Name	Date	Title		
				Created By	SWN	240706	15XX IMS gear housing		
				Checked By			Rev3		
				Scale			Drawing Number	Issue	
				Neutronics INC					
No	Change	Date	Init

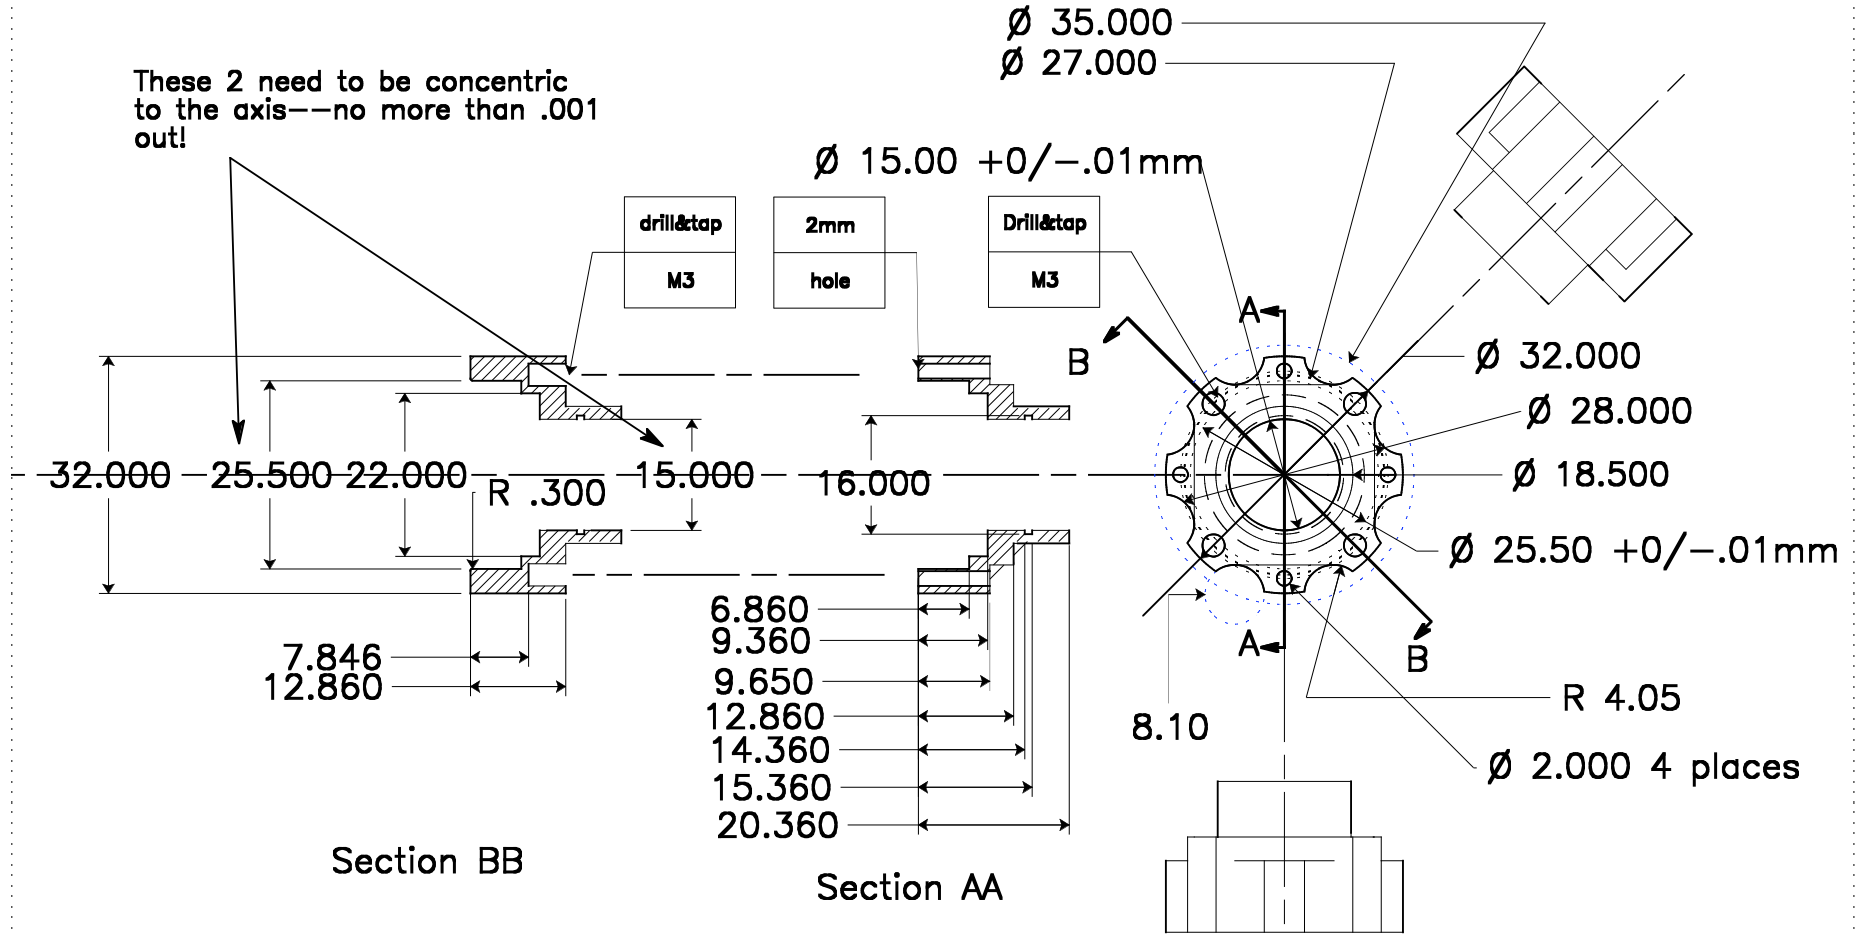
These 2 need to be concentric to the axis--no more than .001 out!

- 1)Blue lines and numbers are to help make layout clearer
- 2) added missing dimensions and other small changes
